REVIEW NOTES

ROCHESTER ER STP 0162(19) – BRIDGE NO. 13

TRAFFIC CONTROL PLAN SUBMITTAL

August 14, 2014

Typical Application 10

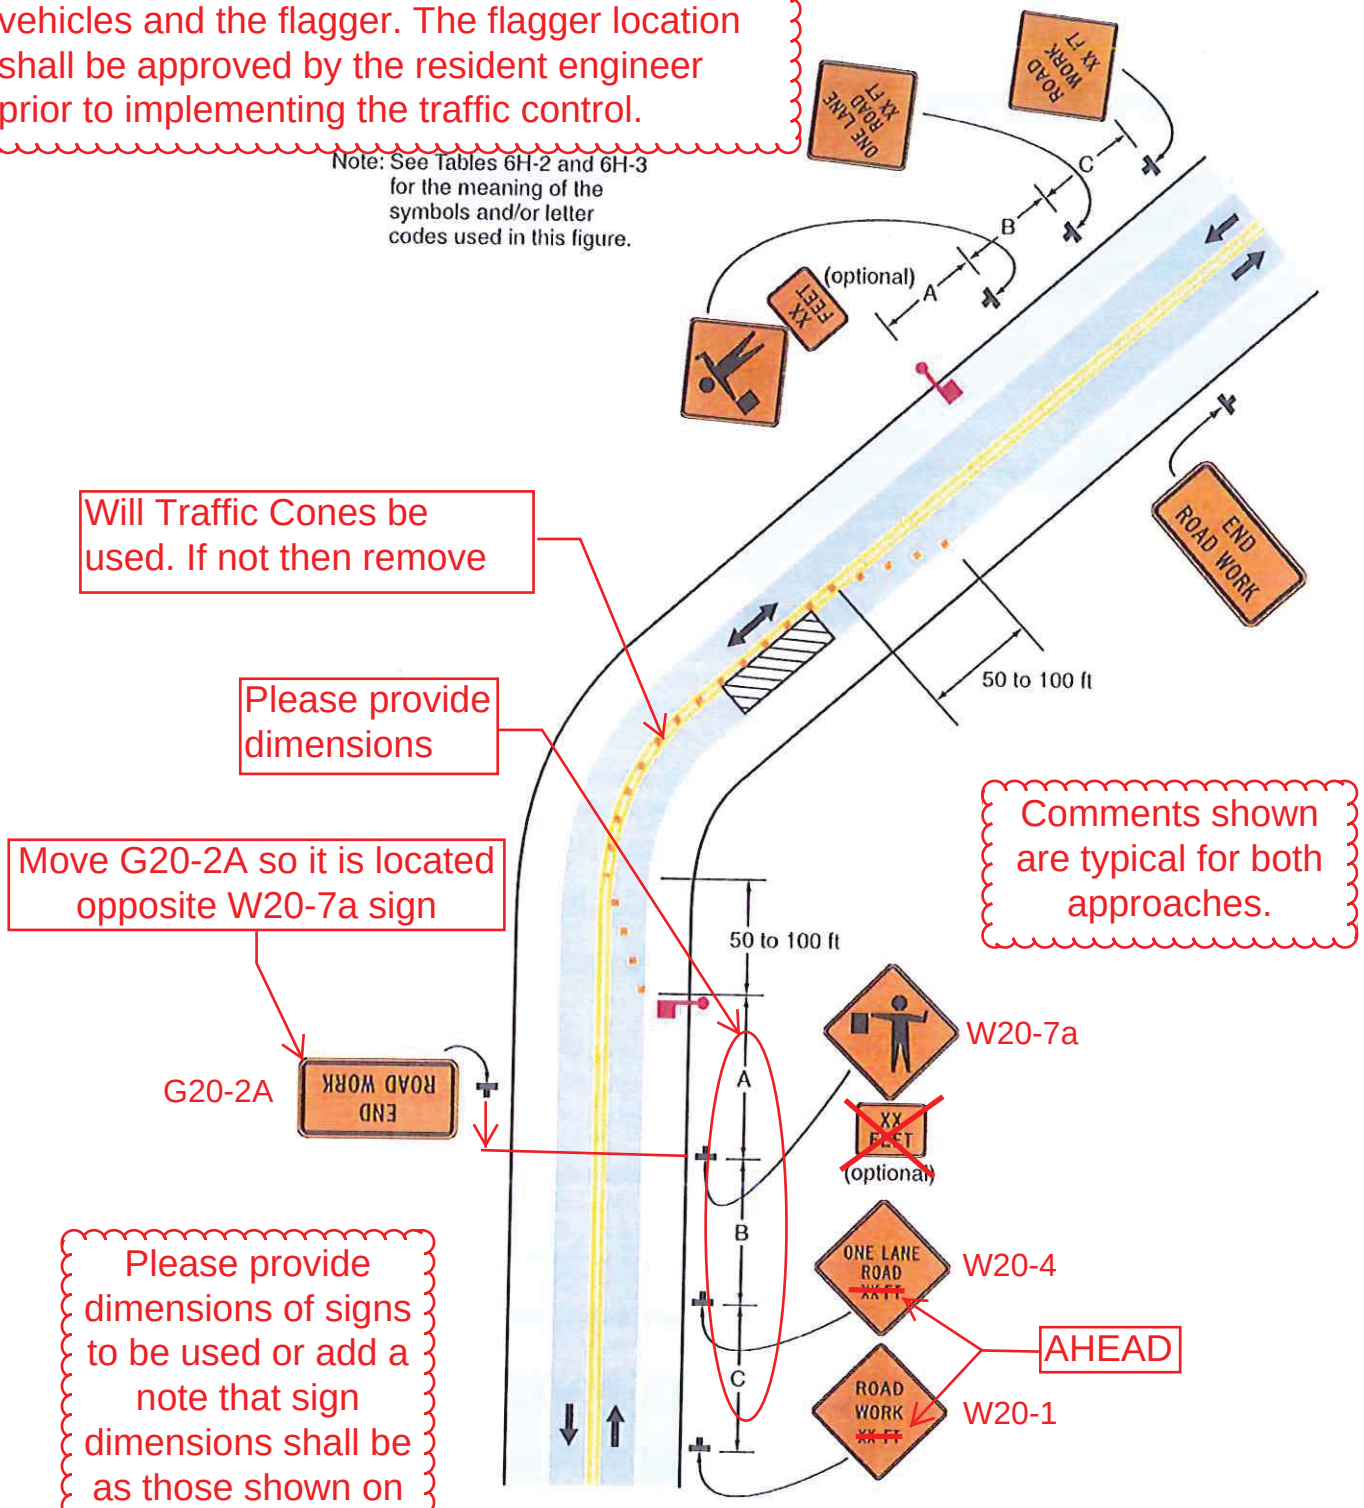
Will Traffic Cones be used. If not then remove

Please provide dimensions

Move G20-2A so it is located opposite W20-7a sign

Comments shown are typical for both approaches.

Please provide dimensions of signs to be used or add a note that sign dimensions shall be as those shown on Sheet 193 of the Contract Plans.

REGIONAL TRAFFIC CONTROL PLAN

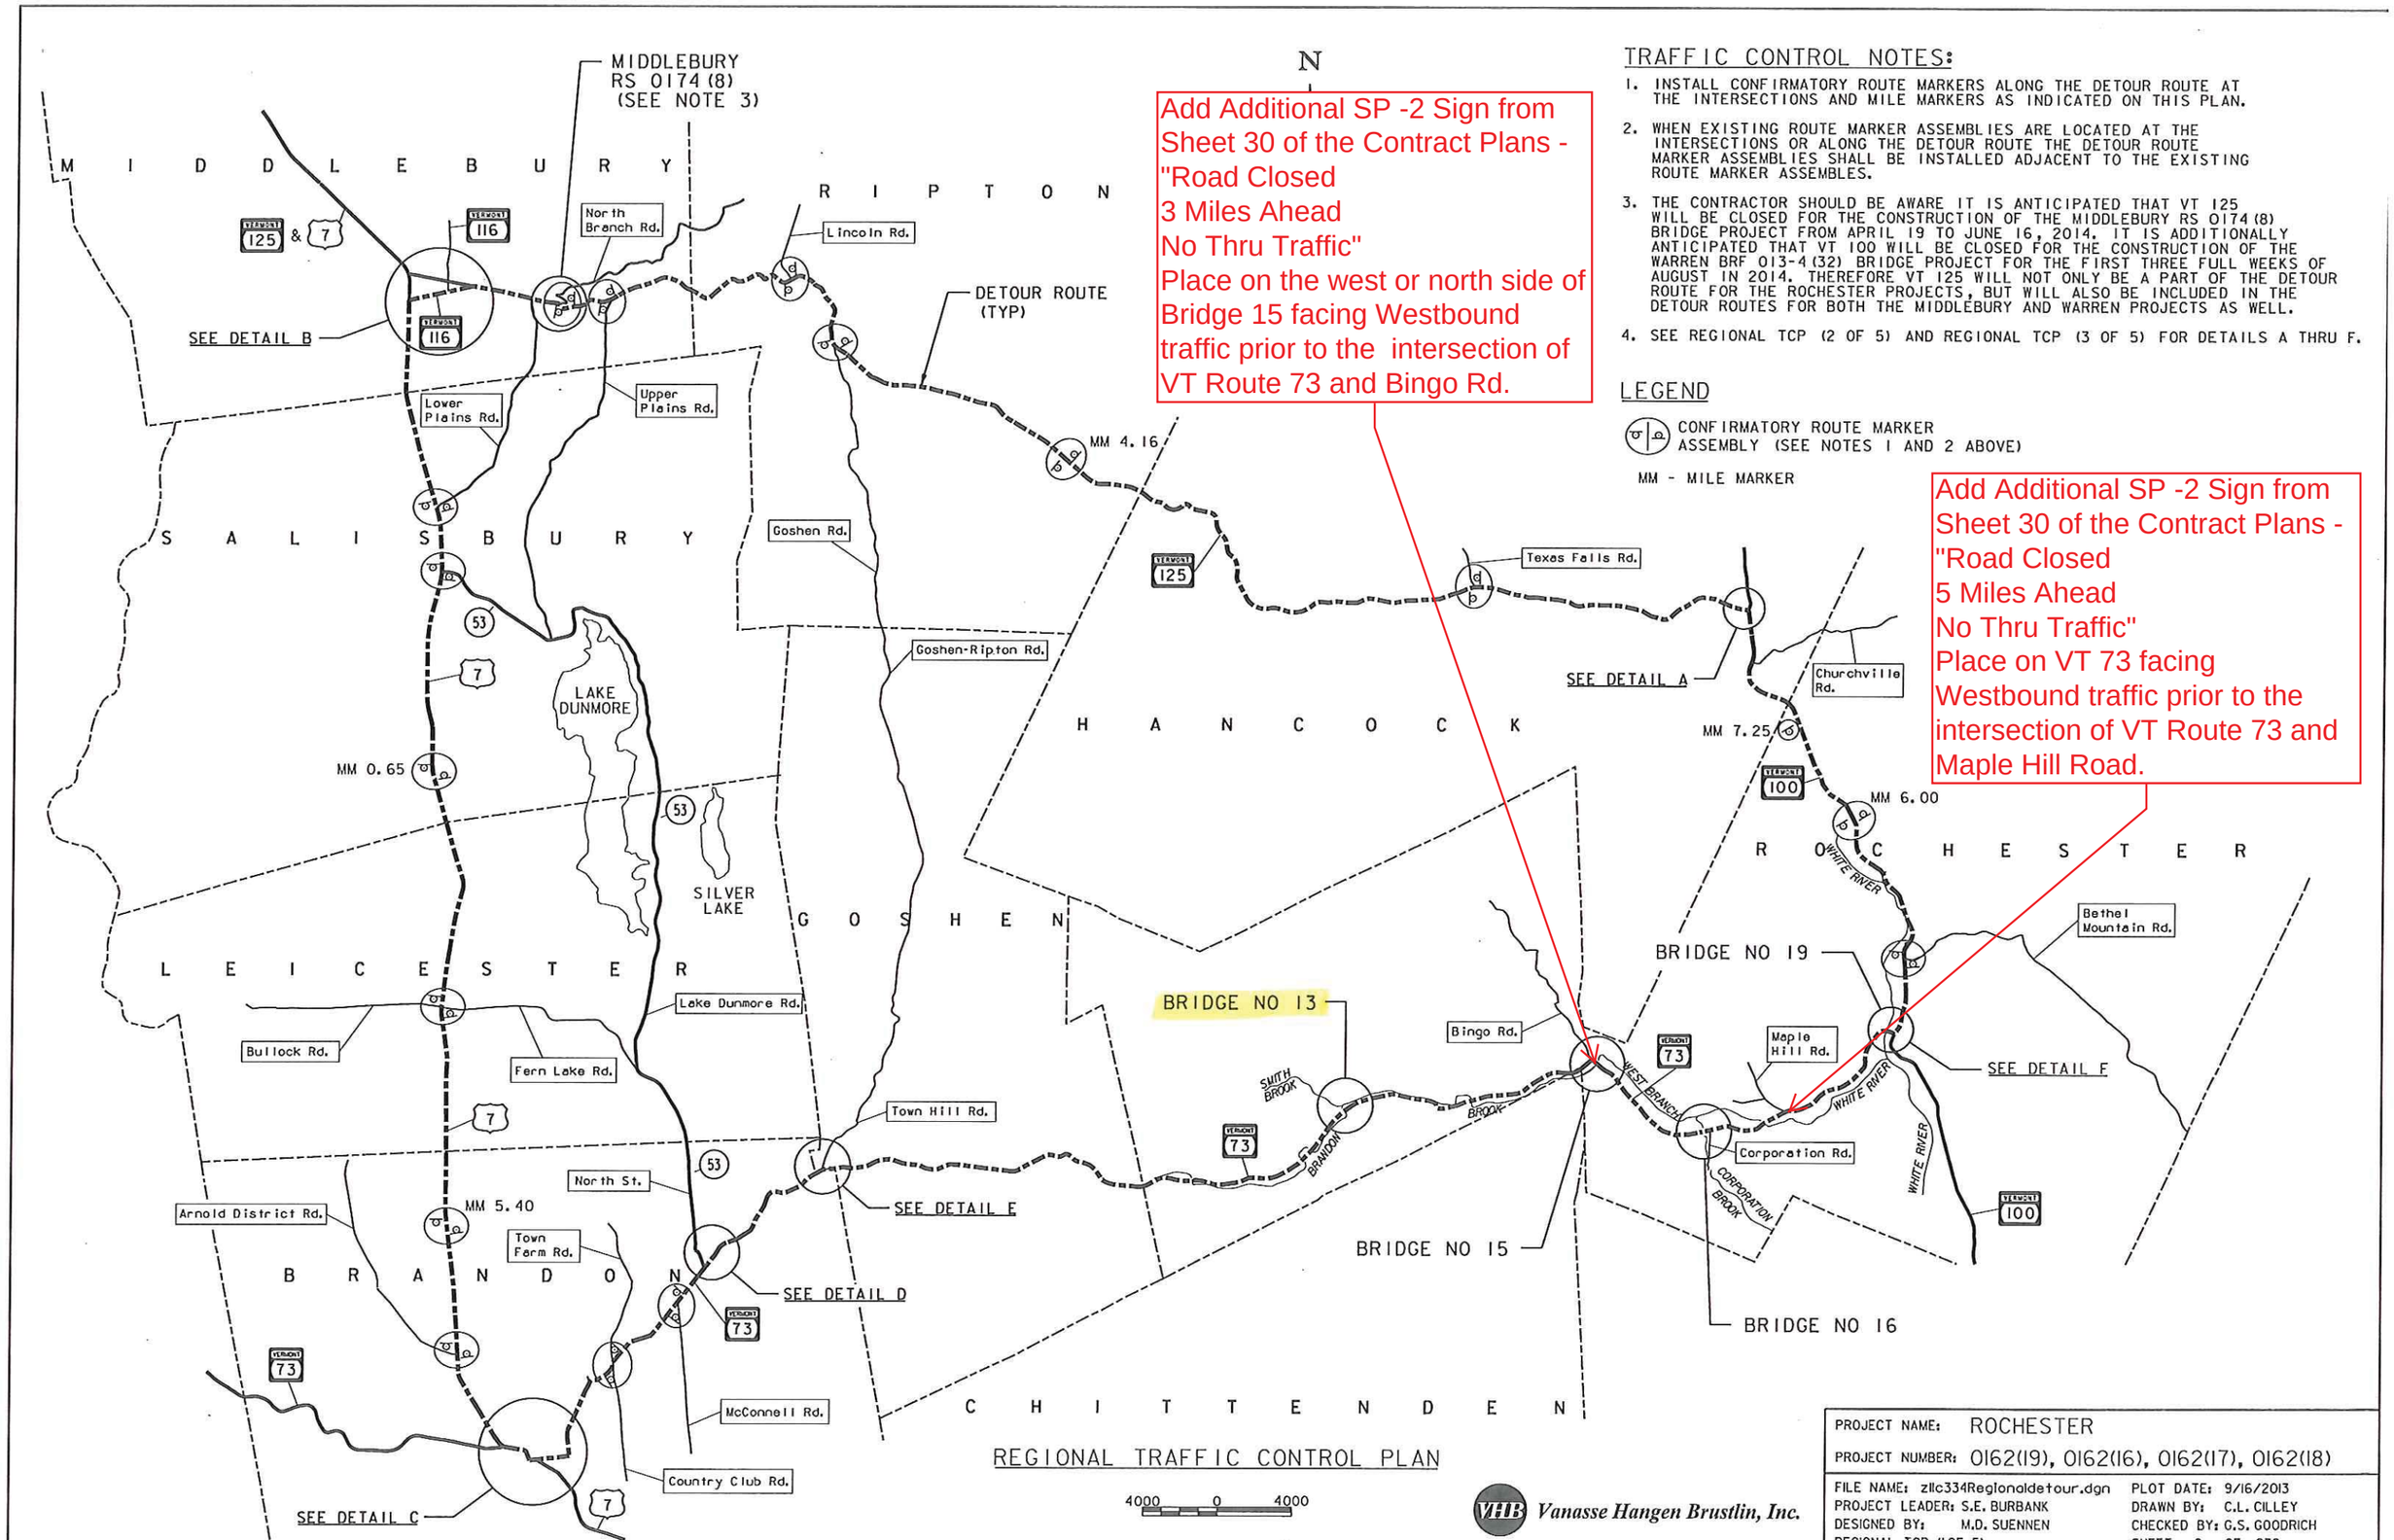
Add Additional SP -2 Sign from Sheet 30 of the Contract Plans - "Road Closed
3 Miles Ahead
No Thru Traffic"
Place on the west or north side of Bridge 15 facing Westbound traffic prior to the intersection of VT Route 73 and Bingo Rd.

Add Additional SP -2 Sign from Sheet 30 of the Contract Plans - "Road Closed
5 Miles Ahead
No Thru Traffic"
Place on VT 73 facing Westbound traffic prior to the intersection of VT Route 73 and Maple Hill Road.

DETAIL D
NOT TO SCALE

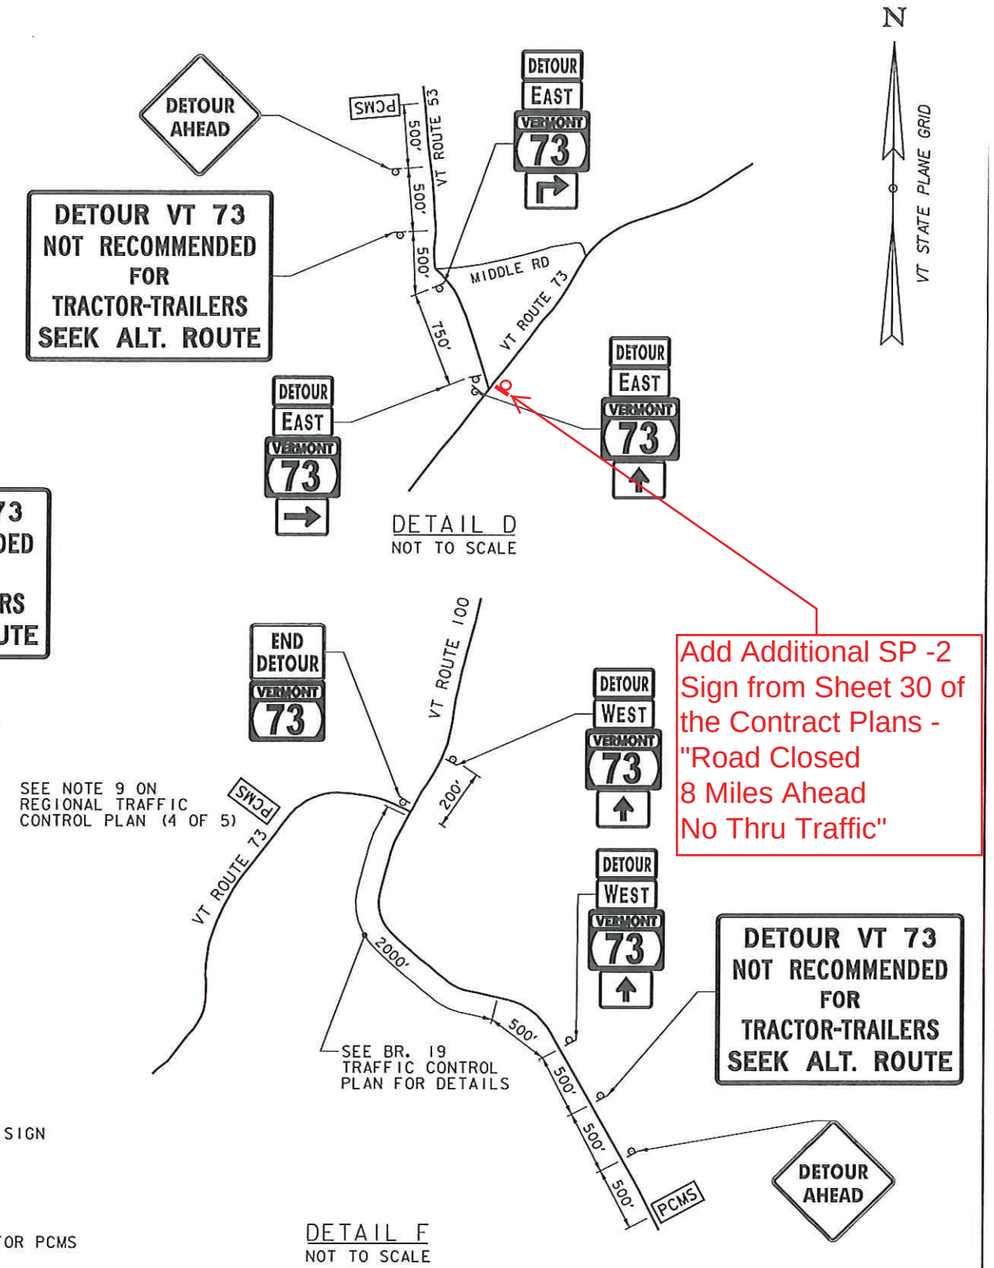
Add Additional SP -2 Sign from Sheet 30 of the Contract Plans - "Road Closed 8 Miles Ahead No Thru Traffic"

DETAIL E
NOT TO SCALE

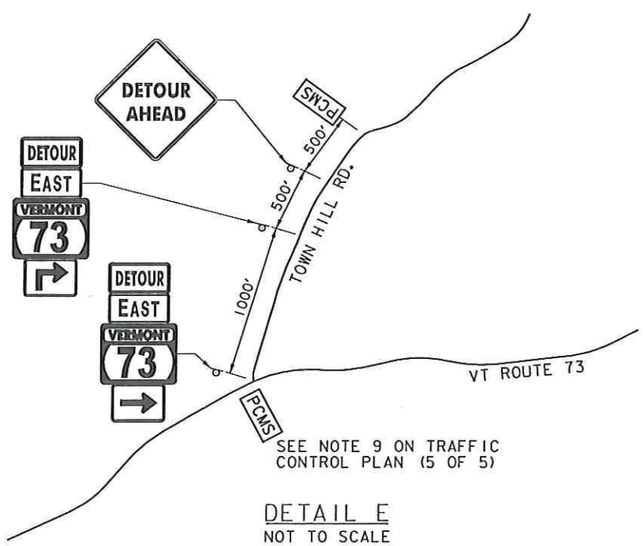
Add Additional SP -2 Sign from Sheet 30 of the Contract Plans - "Road Closed 10 Miles Ahead No Thru Traffic"
